Clonburris SDZ, Reg ref: SDZ22A0010  
Dublin 22

Ronan Mac Diarmada & Associates

## COMPLIANCE RESPONSE

## Condition Request 26 (i - xv )

### Central Open Space

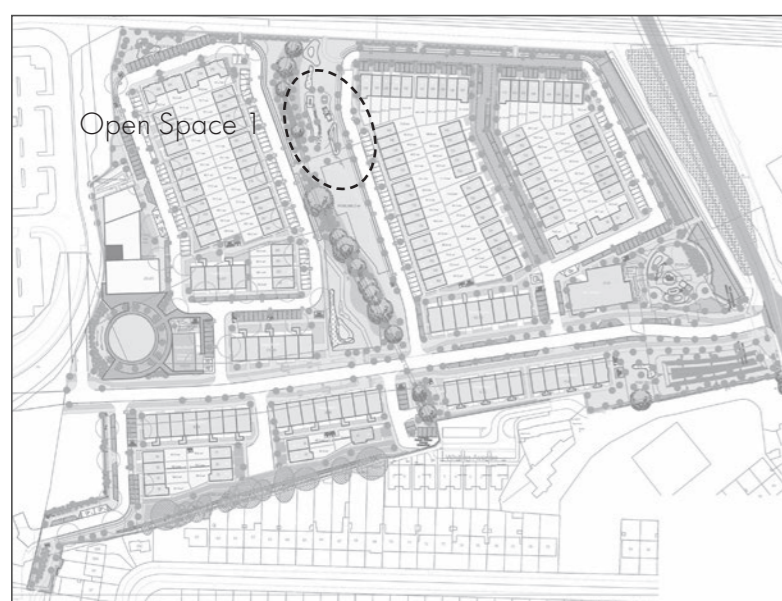
(iv) Revised play design at central open space  
 (v) Open space areas along all roads to incorporate natural SuDS for attenuation, water treatment, amenity and biodiversity purposes as outlined in SDZ. Details of all natural SuDS features including swales, rain gardens, bioretention tree pits, channel rills, filter strips, ponds, detention basins with lower areas allowed to fill first (low flow channels), wetlands etc. to be agreed with Public Realm

(iv) The central open space has been revised to incorporate SuDS elements as well as revised play items. The use of natural play elements and raised mounding will provide an environmentally friendly approach to play.

(v) Open space areas along all roads incorporate natural SuDS for attenuation, water treatment, amenity and biodiversity purposes as outlined in SDZ. Please refer to details shown for treatment of swales and detention basin in SUDS Strategy document.

### Central Open Space

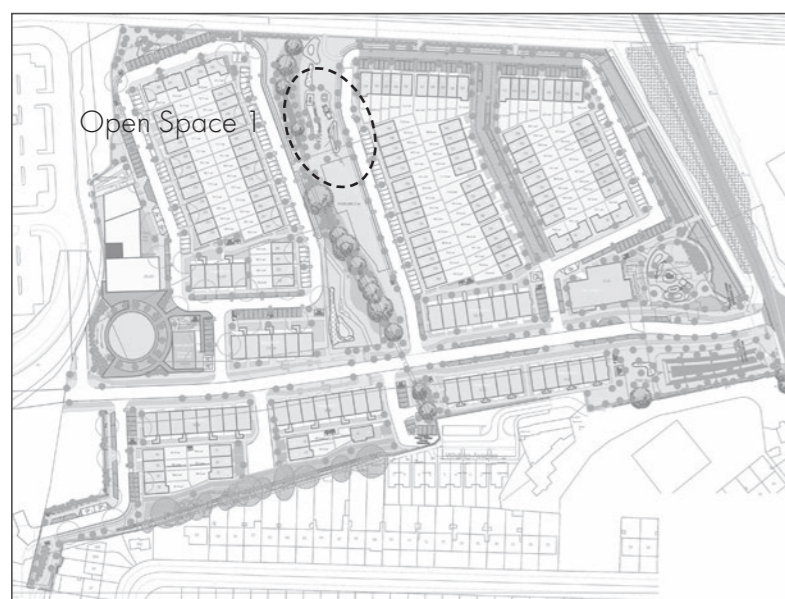
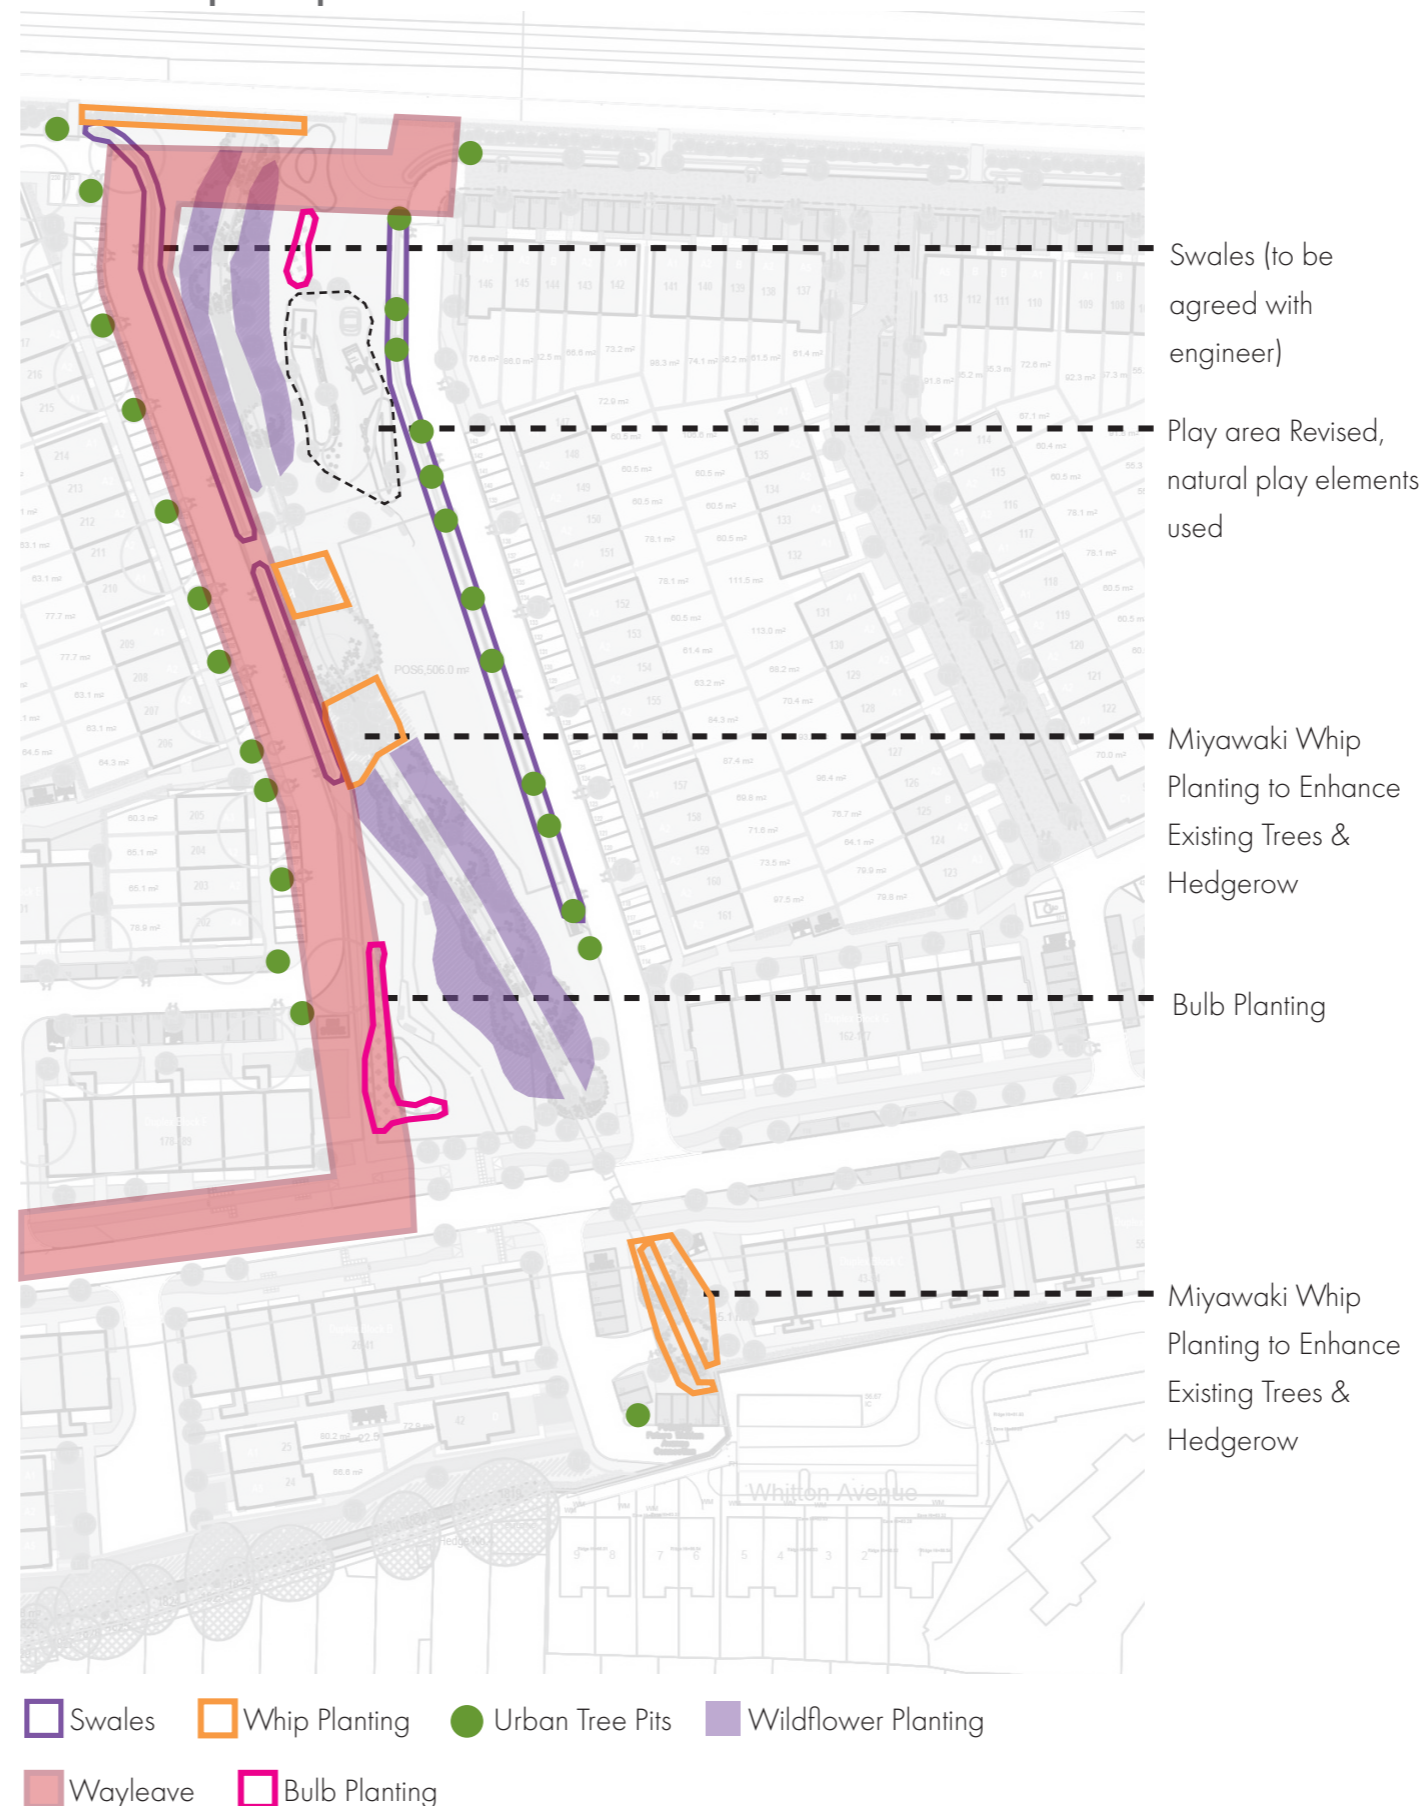
(iv) Revised play design at central open space  
 (v) Open space areas along all roads to incorporate natural SuDS for attenuation, water treatment, amenity and biodiversity purposes as outlined in SDZ. Details of all natural SuDS features including swales, rain gardens, bioretention tree pits, channel rills, filter strips, ponds, detention basins with lower areas allowed to fill first (low flow channels), wetlands etc. to be agreed with Public Realm

(iv) The central open space has been revised to incorporate SuDS elements as well as revised play items. The use of natural play elements and raised mounding will provide an environmentally friendly approach to play.

(v) Open space areas along all roads incorporate natural SuDS for attenuation, water treatment, amenity and biodiversity purposes as outlined in SDZ. Please refer to details shown for treatment of swales and detention basin in SUDS Strategy document.

### Swale Detail

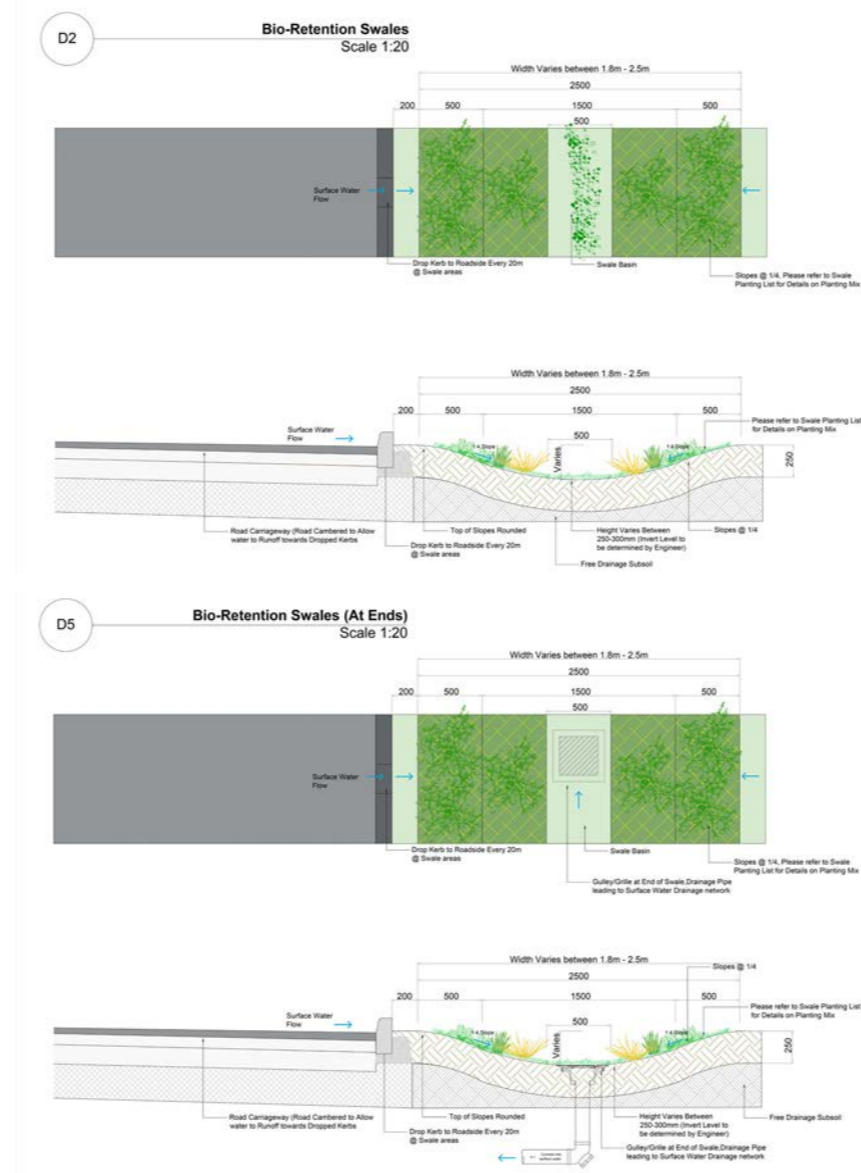
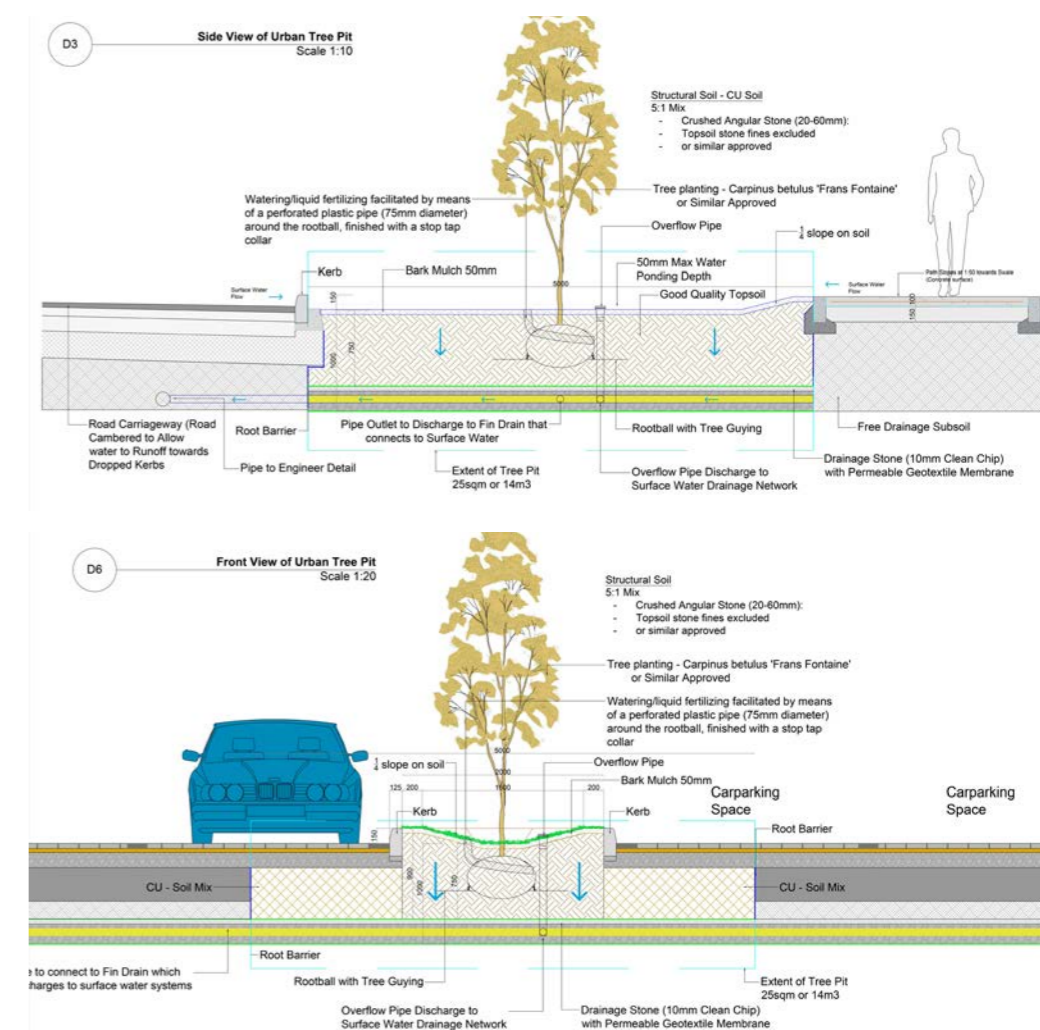
(iv) Revised play design at central open space  
 (v) Open space areas along all roads to incorporate natural Suds for attenuation, water treatment, amenity and biodiversity purposes as outlined in SDZ. Details of all natural SuDS features including swales, rain gardens, bioretention tree pits, channel rills, filter strips, ponds, detention basins with lower areas allowed to fill first (low flow channels), wetlands etc. to be agreed with Public Realm

(iv) The central open space has been revised to incorporate SuDS elements as well as revised play items. The use of natural play elements and raised mounding will provide an environmentally friendly approach to play.

(v) Open space areas along all roads incorporate natural Suds for attenuation, water treatment, amenity and biodiversity purposes as outlined in SDZ. Please refer to details shown for treatment of swales and detention basin in SUDS Strategy document.

Also, please refer to SUDS Strategy Document included for details on Tree Pits, Swales and Raingardens.

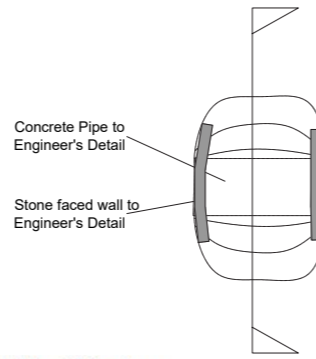
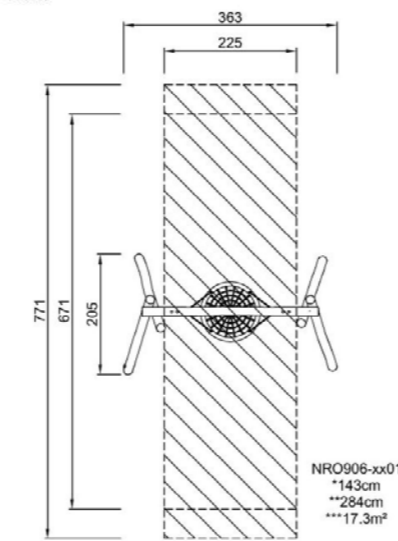
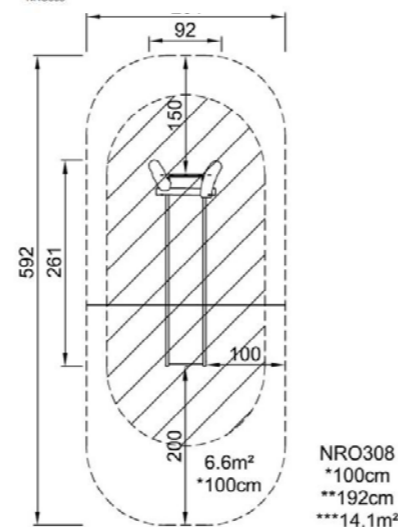
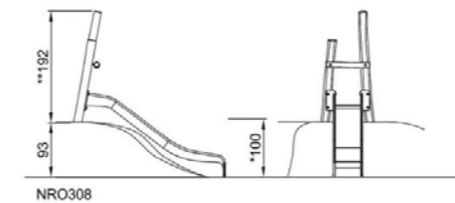
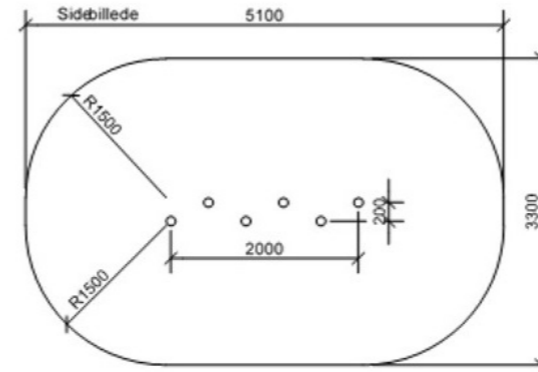
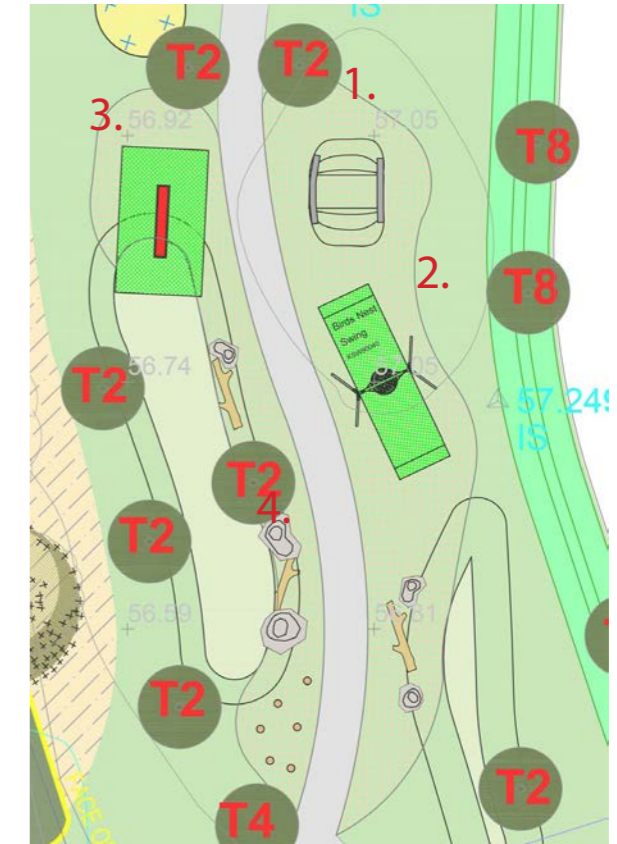
(iv) Revised play design at central open space

(v) Open space areas along all roads to incorporate natural SuDS for attenuation, water treatment, amenity and biodiversity purposes as outlined in SDZ. Details of all natural SuDS features including swales, rain gardens, bioretention tree pits, channel rills, filter strips, ponds, detention basins with lower areas allowed to fill first (low flow channels), wetlands etc. to be agreed with Public Realm

(xv) Details of all play items and natural play features to be provided and agreed with SDCC Public Realm Section. All play areas must be universally accessible.

(iv) The central open space has been revised to incorporate SuDS elements as well as revised play items.

(v) Open space areas along all roads incorporate natural SuDS for attenuation, water treatment, amenity and biodiversity purposes as outlined in SDZ. Please refer to details shown for treatment of swales and detention basin as per coordination with Engineer.

(xv) Details of play items and natural play features are provided in response and will be agreed with SDCC Public Realm Section prior to works. All play areas will be universally accessible.

### Native Hedge & Existing Hedge Planting

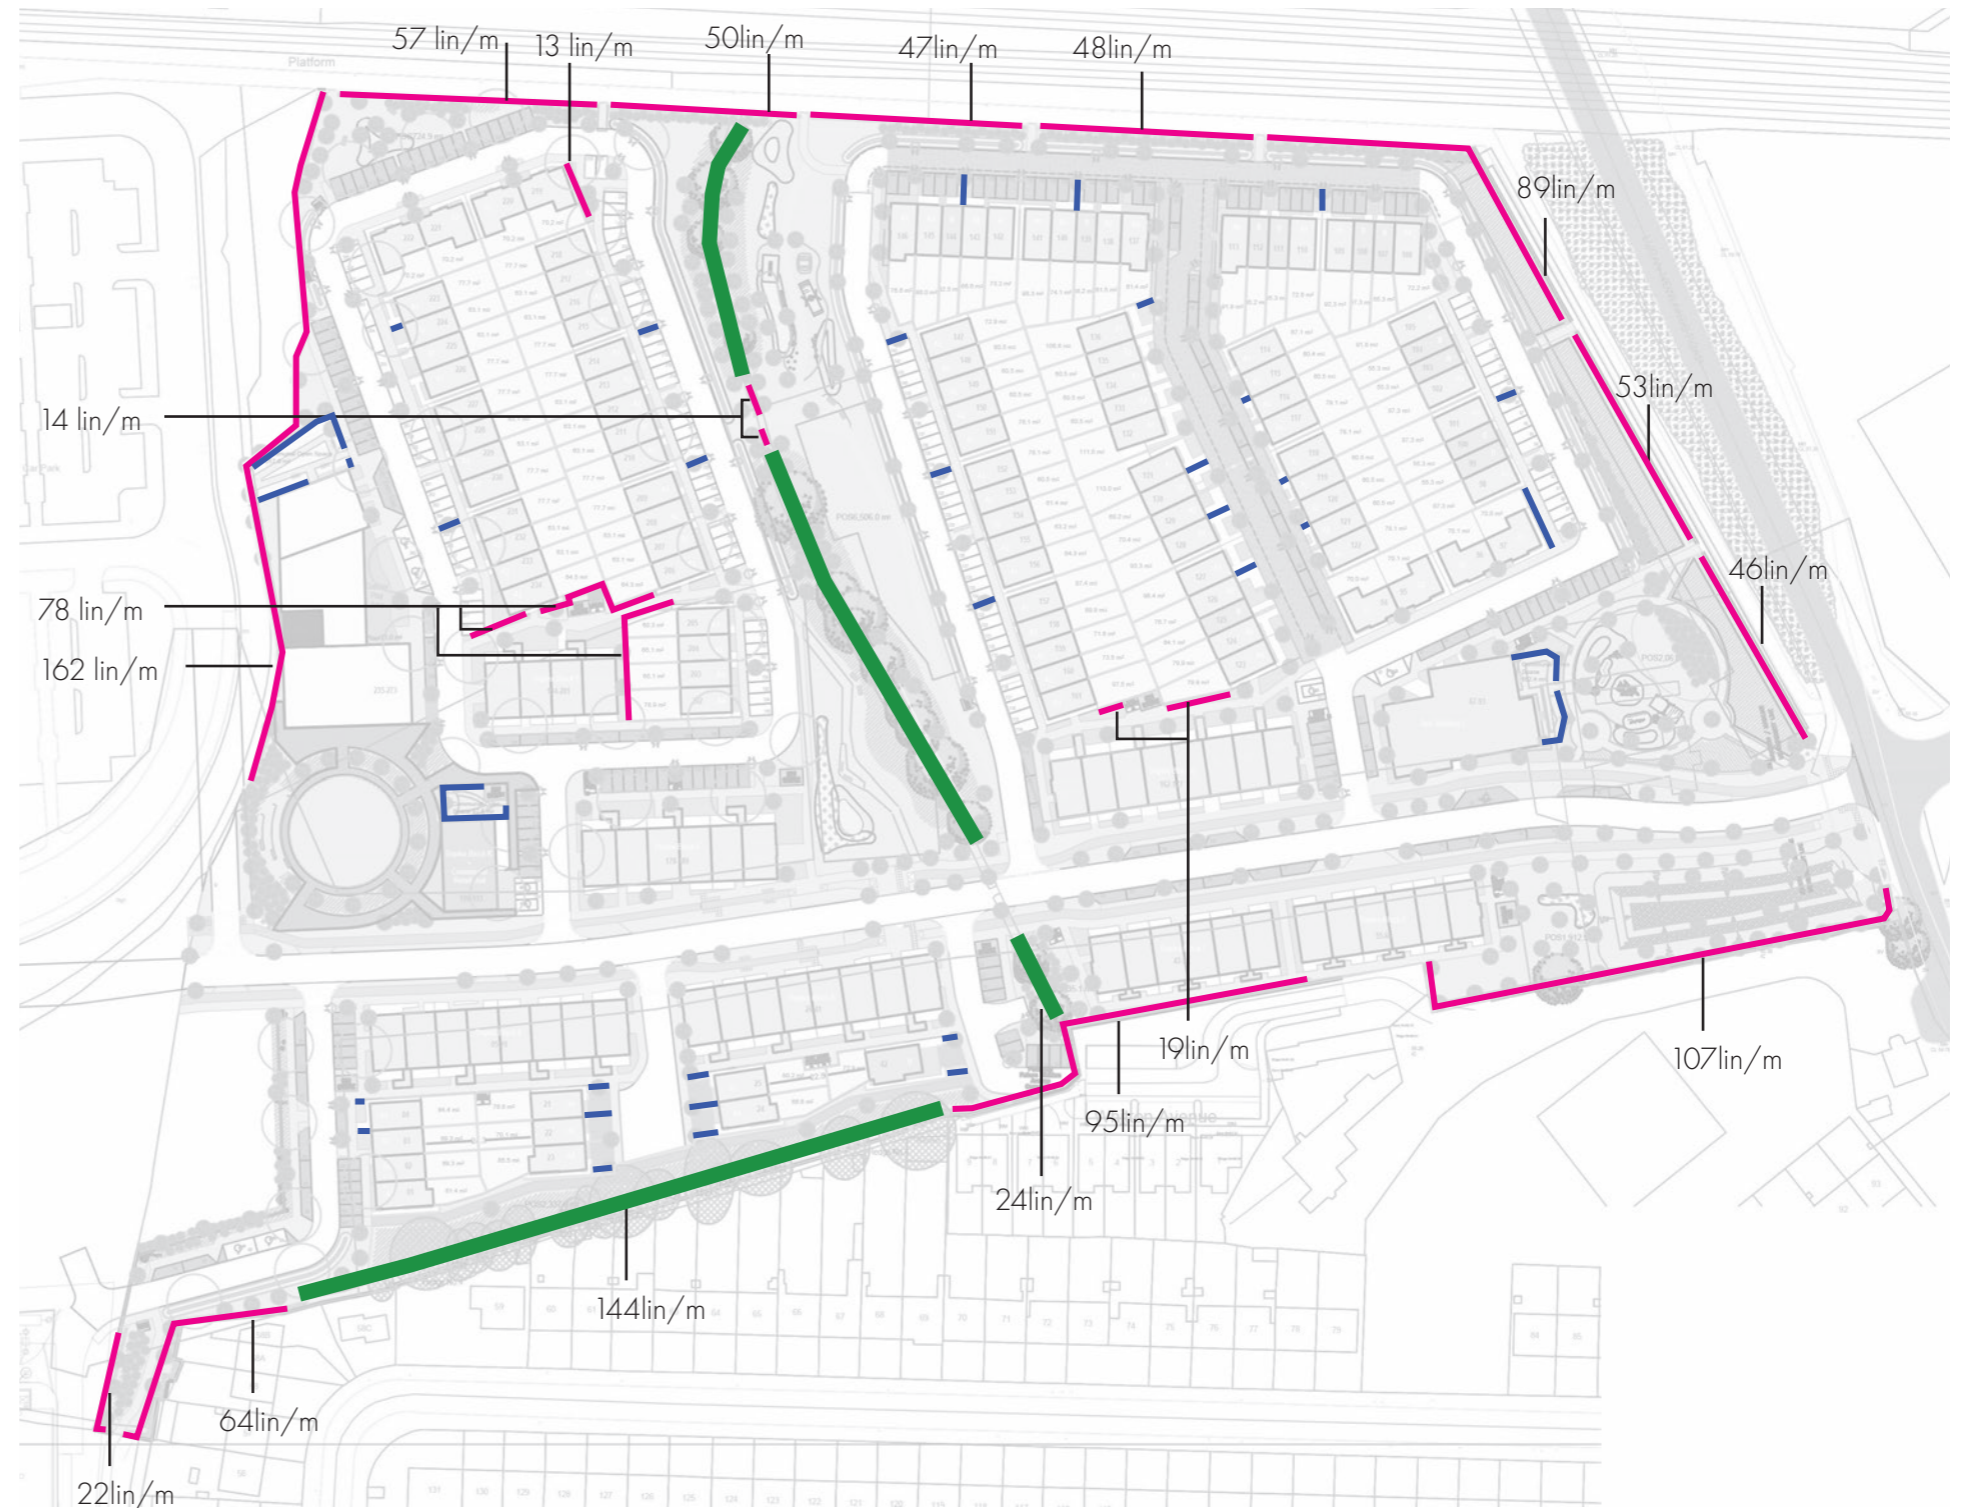
(xiii) Native species shall be used for formal hedging proposed within Clonburris SDZ e.g., residential. Suitable species include hazel *Corylus avellana*, wild privet *Ligustrum vulgare*, guelder rose *Viburnum opulus* and yew *Taxus baccata*

(xiii) Hedging to residential areas consists of native species as mentioned in the condition request. Hedging in between residential units will be *Ligustrum vulgare*.

- Existing Hedge Retained
- Proposed Native Hedge
- Proposed Formal Hedge - *Ligustrum vulgare*
